V2500-A1 SERIES PROPULSION SYSTEMS SERVICE BULLETIN

This document transmits Revision 3 to Service Bulletin EV2500-73-0040

V2500-ENG-73-0040

ENGINE – FUEL AND CONTROL – FUEL TUBES – FUEL METERING UNIT TO FUEL DIVERTER VALVE
SERVO TUBES RE-ROUTED

Schematic view of servo fuel tubes showing clipping point arrangement - After alteration
Figure 3

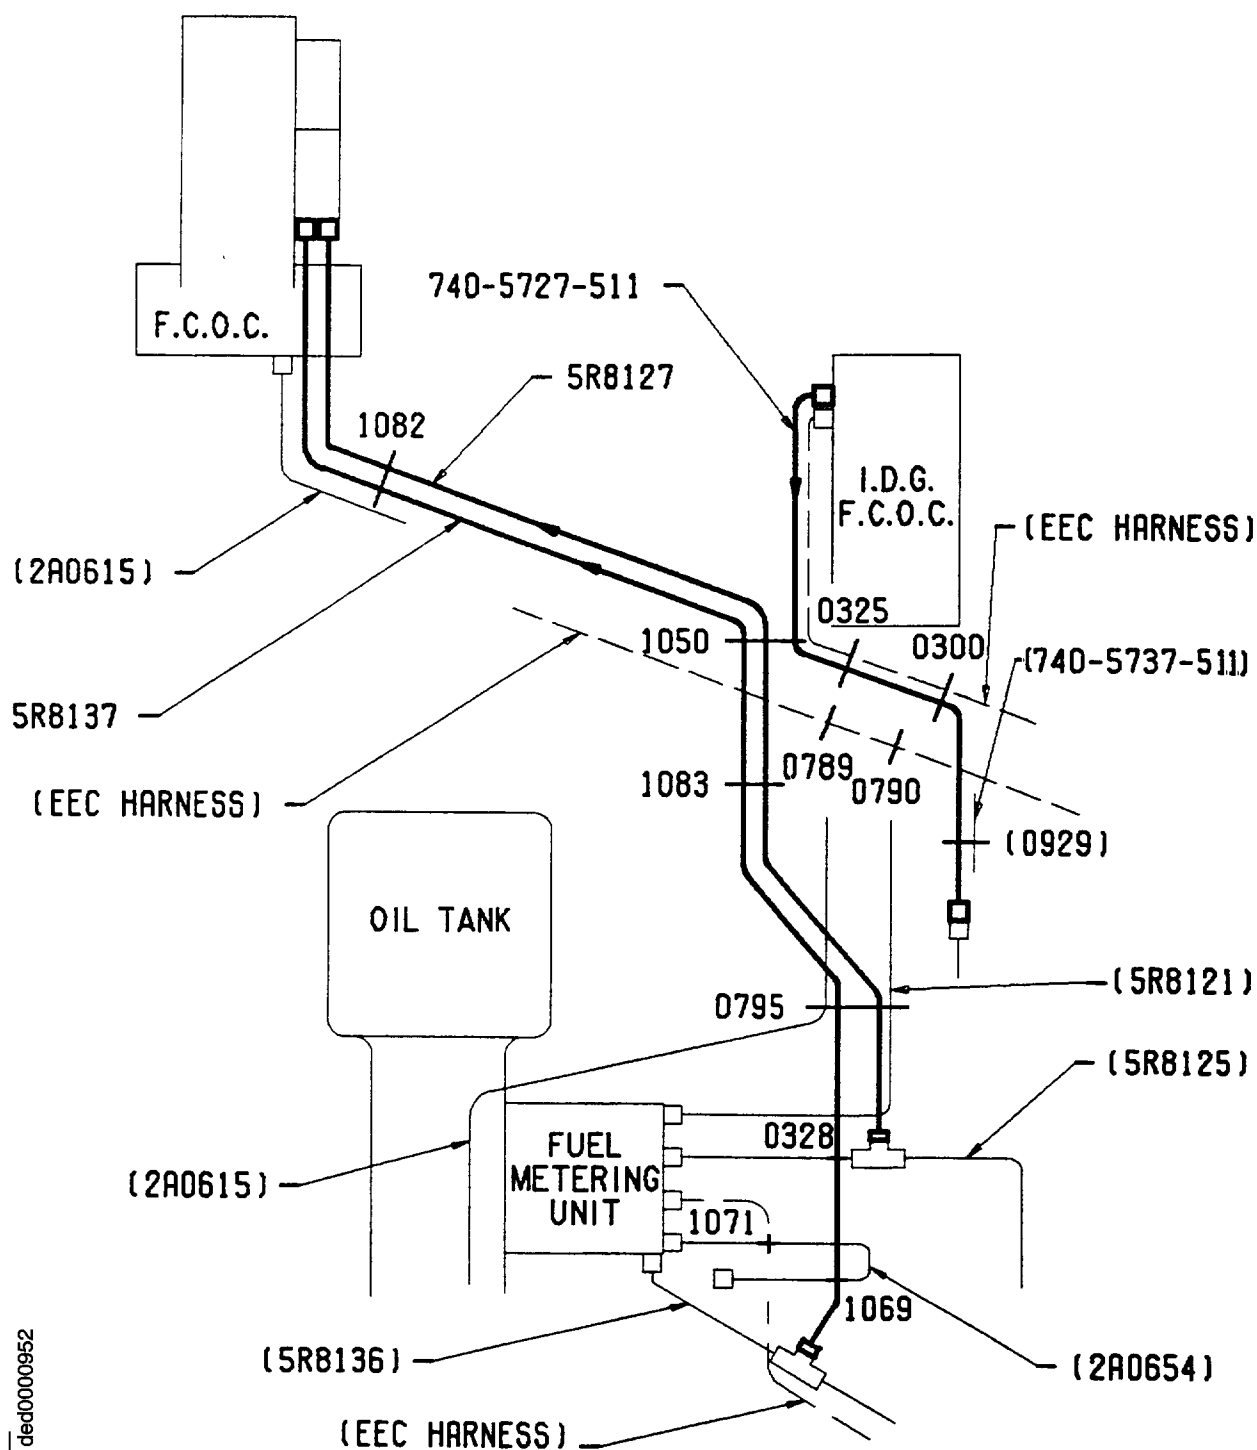
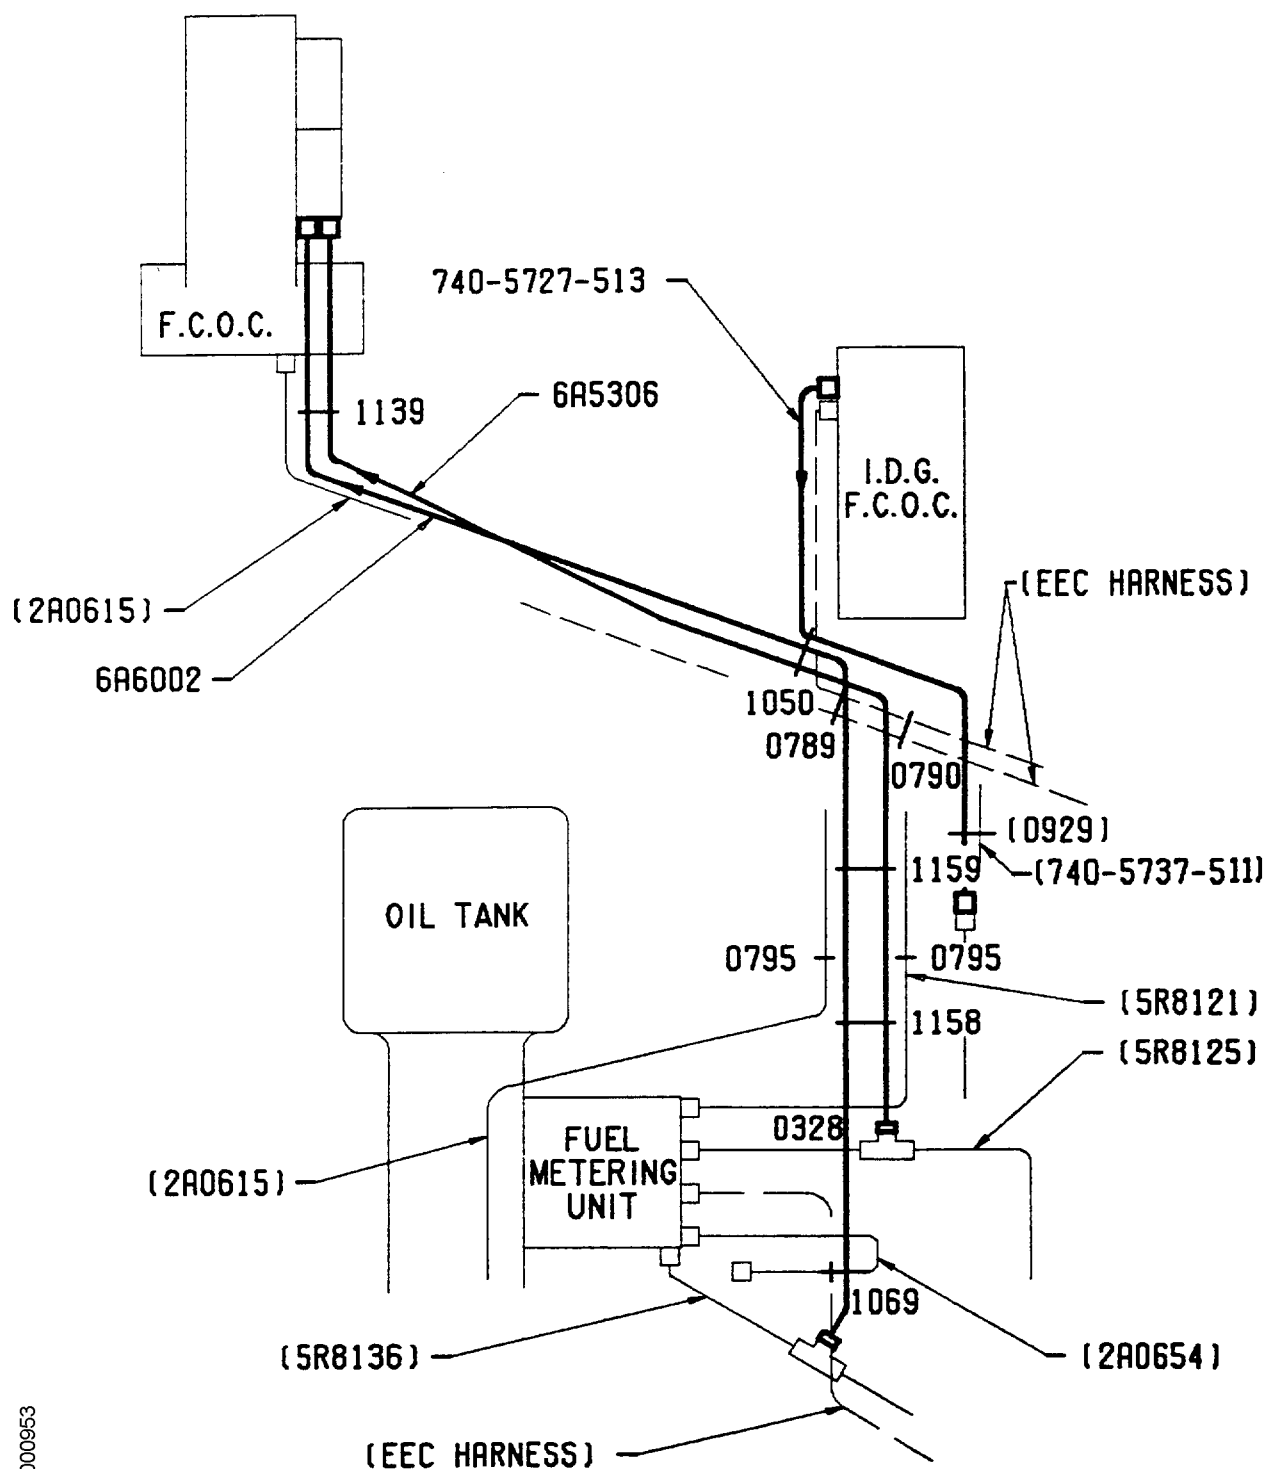
The two existing titanium servo fuel tubes are replaced by tubes produced in steel which has a far higher resistance to fretting.

The new tubes are re-routed closer to the fan case through new and existing clipping points. Existing clips are replaced by a type which has proved to have improved durability.

The tubes are now supported at new Clipping Points 1139, 1158 and 1159 and at existing Clipping Points 1050 and 1069. The tubes are no longer clipped at Clipping Point 0795 and existing Clipping Points 0325, 0328, 1082 and 1083 are deleted.

- R (1) Install reworked 740-5727-513, IDG oil tube assembly, new 6A5306 and
R 6A6002 servo fuel tube assemblies to the fan case by the approved
R procedures in the Engine Manual, 72-00-32 and 72-00-60, Installation
R (Refer to Figure 3).
- (2) Re-assemble existing Clipping Point 0929. Install new 400WSS12 clip to 740-5727-513 oil tube and new 400WSS10 clip to 740-5737-511 tube respectively using AS21408 bolt, SP154D washer and AS41104 clipnut. Torque the nut to 36 to 45 lbfin (4 to 5 Nm). Refer to Figures 3 and 9.

Servo tube clipping details
Figure 6

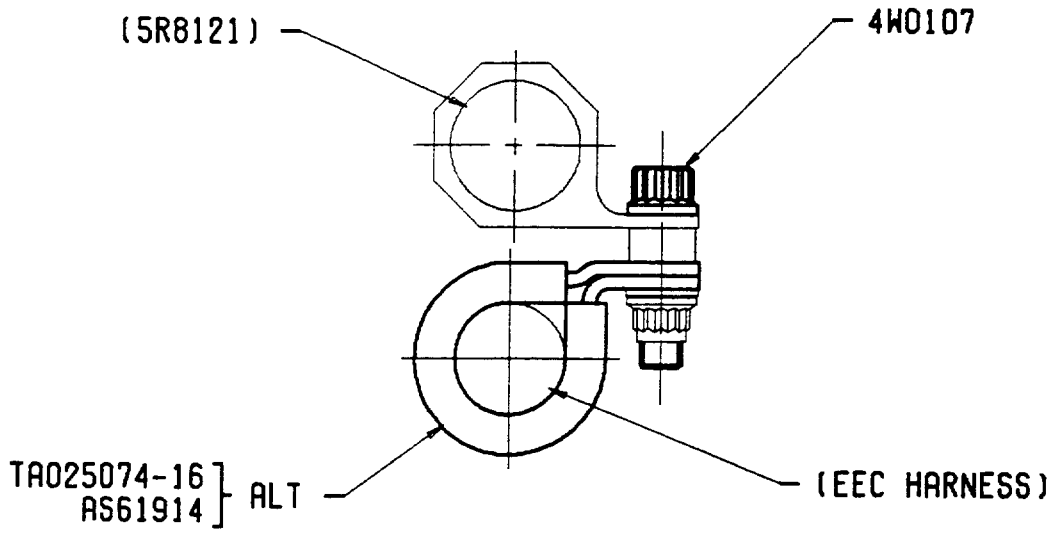
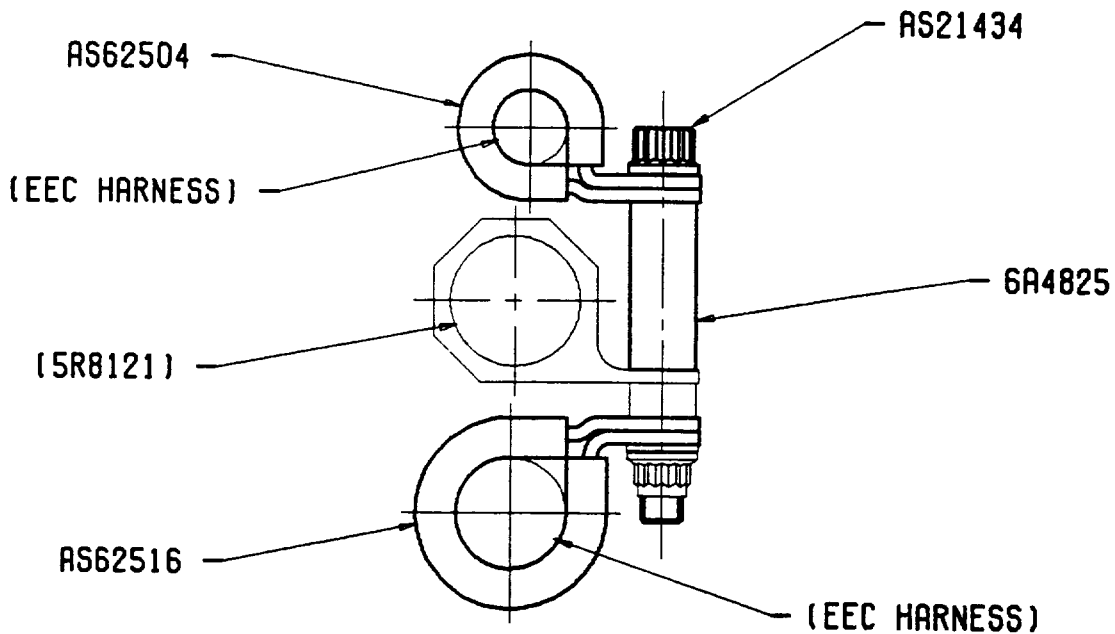
- (5) Secure the EEC harness lead at existing Clipping Point 0789. Remove 4W0001 nut, 4W0107 bolt, 5W1086 washer, AS61914 or TA025074-16 clip and 5W1029 spacer. Install replacement AS62516 clip and AS62504 clip on EEC harness, install AS62504 clip, AS21434 bolt, 6A4825 spacer, 5R8121 tube, 5W1029 spacer, AS62516 clip, 5W1086 washer and 4W0001 nut. Torque the nut to 36 to 45 lbfin (4 to 5 Nm). Refer to Figures 3 and 6.

Servo tube clipping details
Figure 7

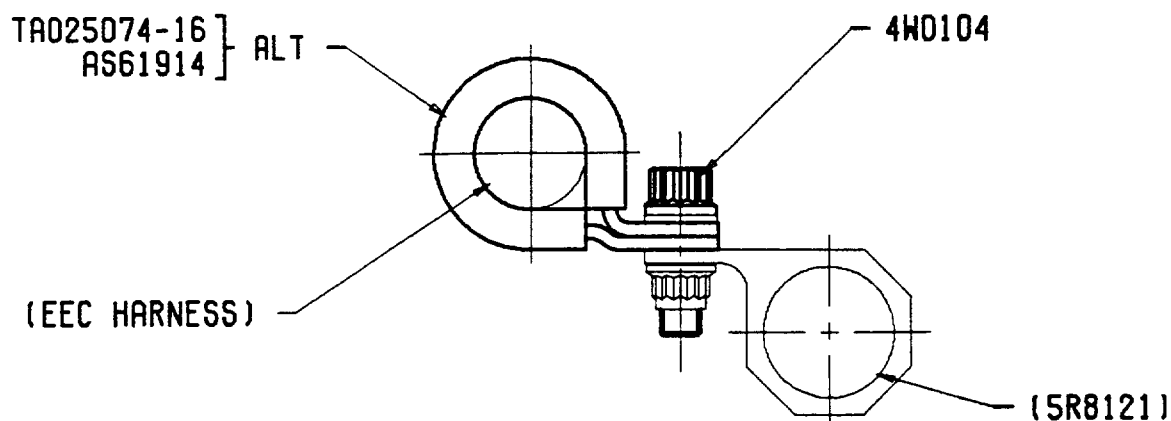
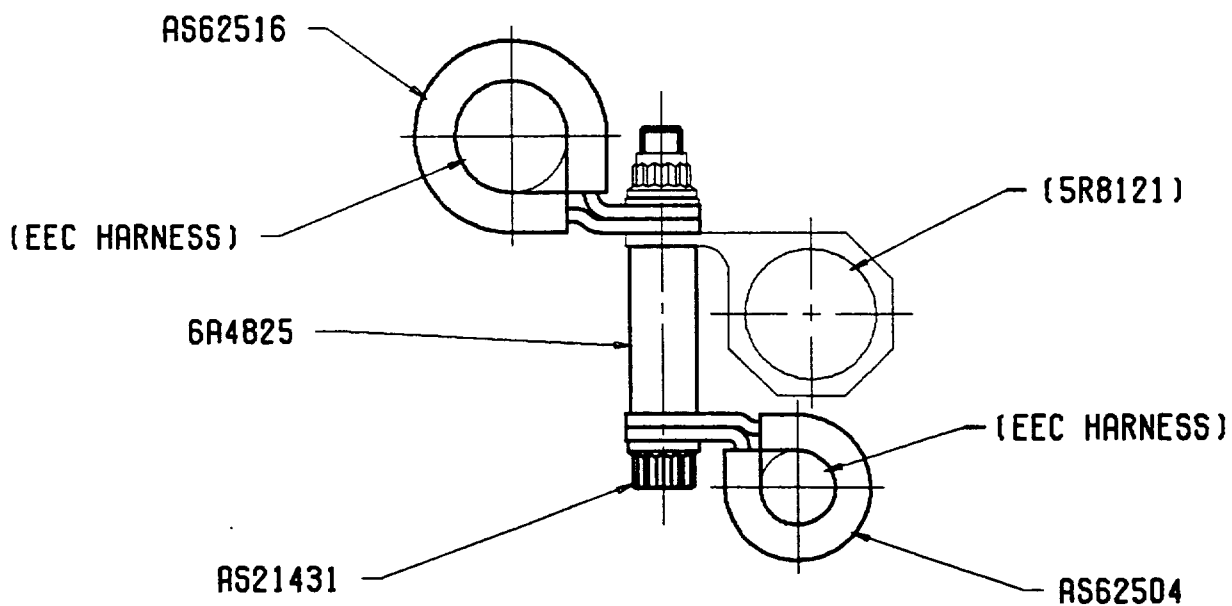
- (3) Find the EEC harness lead to the IDG oil cooler previously clipped at Clipping Points 0300 and 0325. Refer to Figure 2.
- (4) Secure the EEC harness lead at existing Clipping Point 0790. Remove 4W0001 nut, 4W0104 bolt, 5W1086 washer and AS61914 or TA 025074-16 clip, install replacement AS62516 clip and AS62504 clip on EEC harness, install AS62504 clip, AS21431 bolt, 6A4825 spacer, 5R8121 tube, AS62516 clip, 5W1086 washer and 4W0001 nut. Torque the nut to 36 to 45 lbfin (4 to 5 Nm). Refer to Figures 3 and 7.

Servo tube clipping details
Figure 8

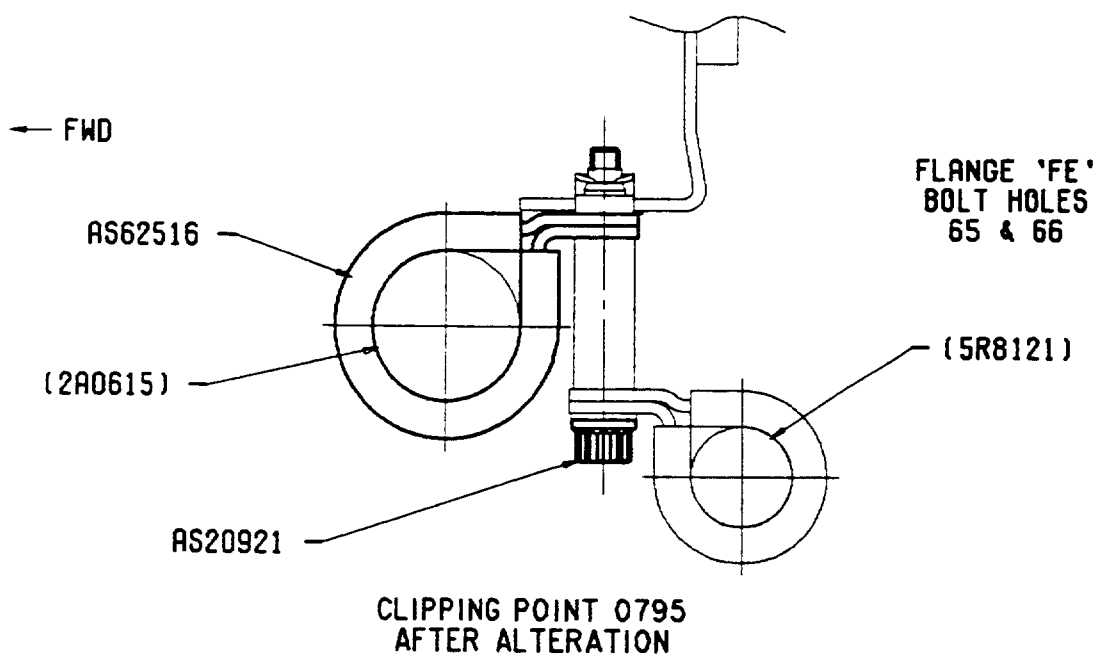
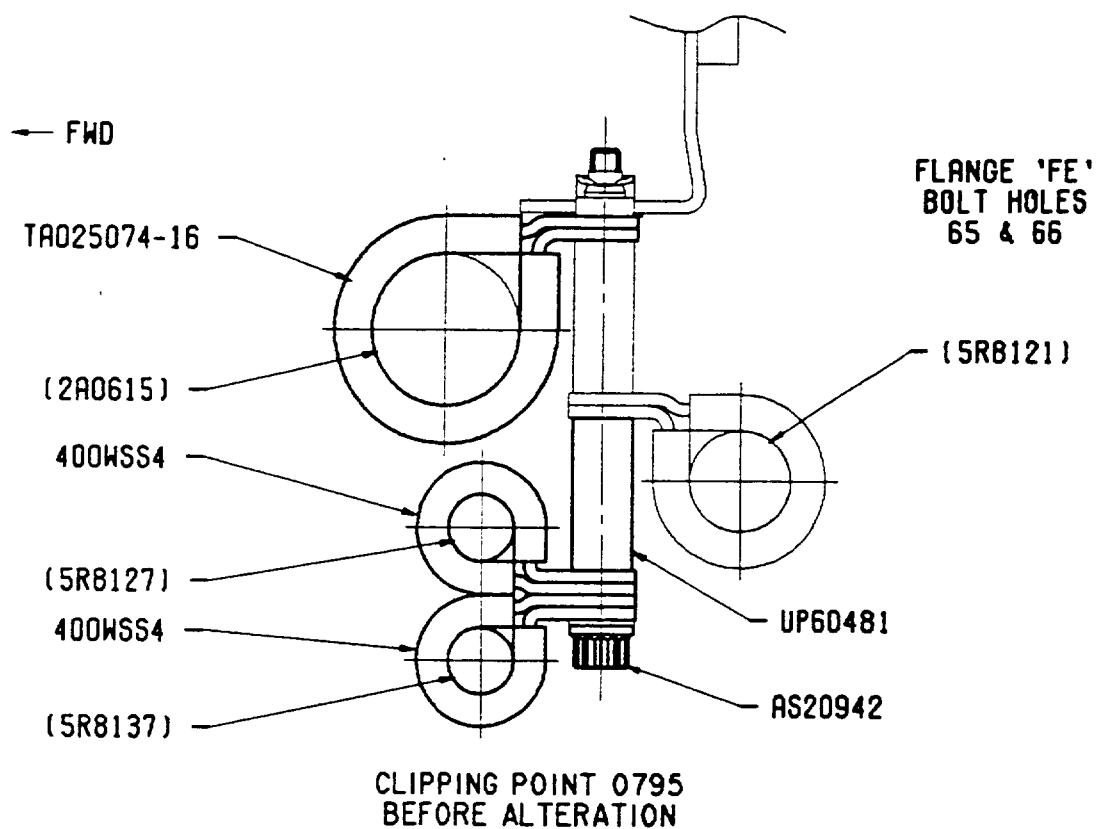
- (6) At existing Clipping Point 0795 install AS62516 clip to 2A0615 tube, install new 400WSS16 clip to 5R8121 tube, AS20921 bolt, AN960XC10L or 5W1086 washer, new 400WSS16 clip, UP10481 spacer, AS62516 clip, 5W8331 bracket and 4W0043 nut clip. Torque the nut to 36 to 45 lbfin (4 to 5 Nm). Refer to Figures 3 and 8.

Servo tube clipping details
Figure 10

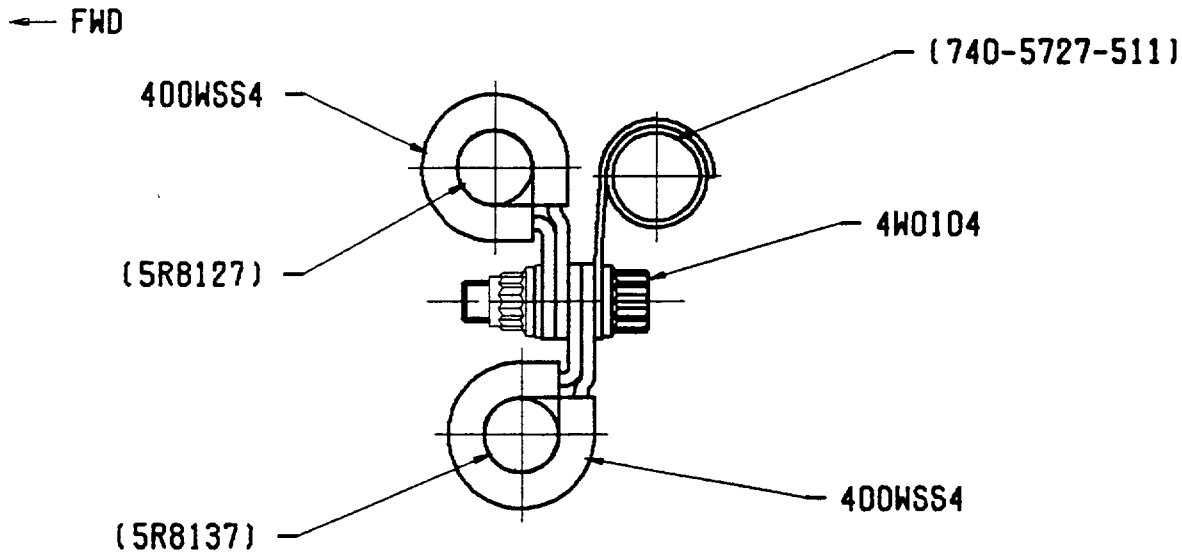
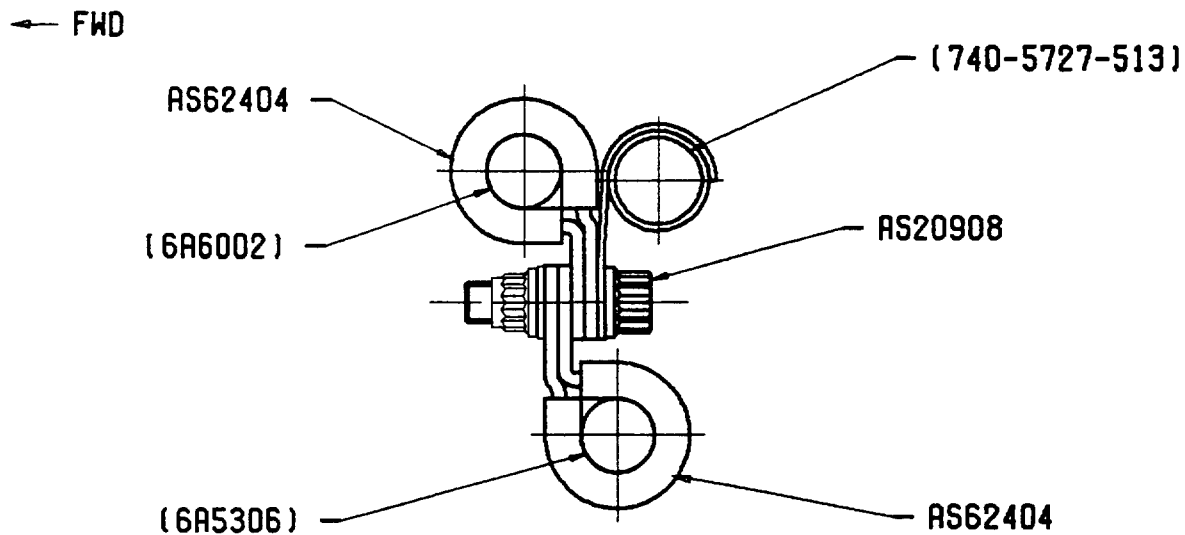
- (13) Secure 6A5306 and 6A6002 fuel tubes at existing Clipping Point 1050. Install AS62404 clips to 6A5306 and 6A6002 tubes, install AS20908 bolt through 740-5727-513 tube clip, AS62404 clip on 6A6002 tube, AS62404 clip on 6A5306 tube, 5W1086 washer and 4W0001 nut. Torque the nut to 36 to 45 lbfin (4 to 5 Nm). Refer to Figures 3 and 10.

Servo tube clipping details
Figure 11

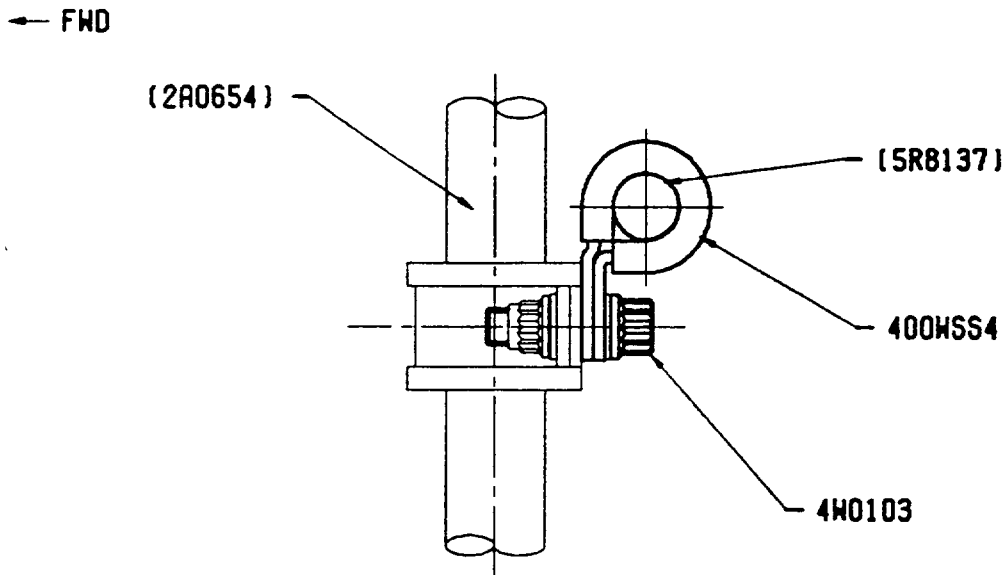
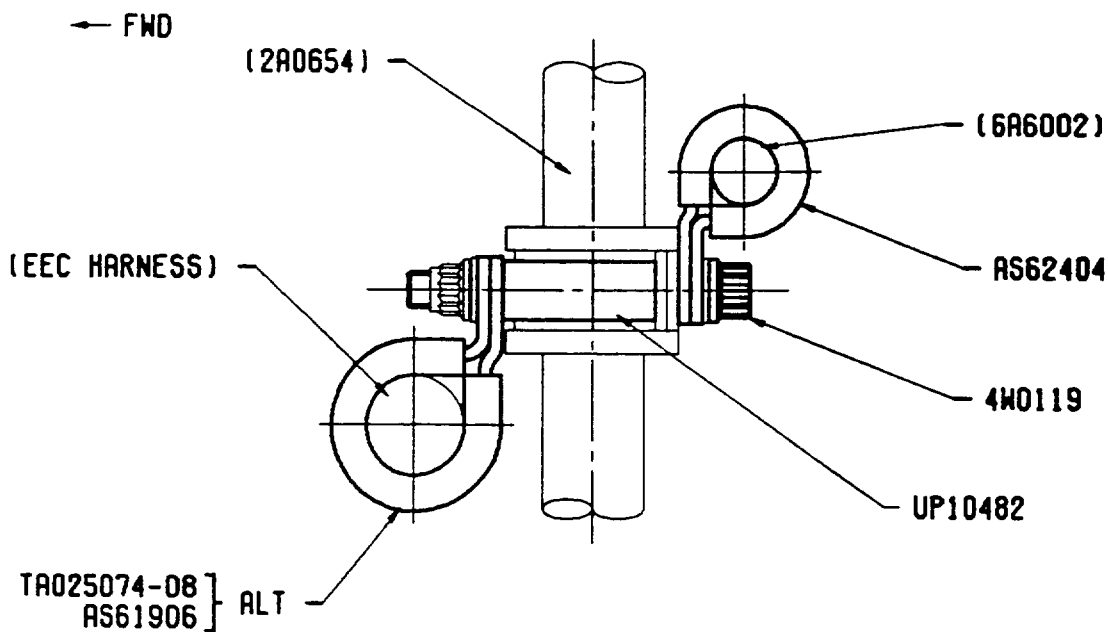
- (7) Secure 6A6002 fuel tube at existing Clipping Point 1069. Install AS62404 clip to 6A6002 tube, install new 400WSS6 clip to 2A0654 tube, install AS61906 or TA025074-08 clip to the EEC harness lead, install 4W0119 bolt, 5W1086 washer through AS62404 clip on 6A6002 tube, new 400WSS6 clip on 2A0654 tube UP10482 spacer, AS61906 clip on EEC harness lead, 5W1086 washer and 4W0001 nut. Torque the nut to 36 to 45 lbfin. (4 to 5 Nm). Refer to Figures 3 and 11.
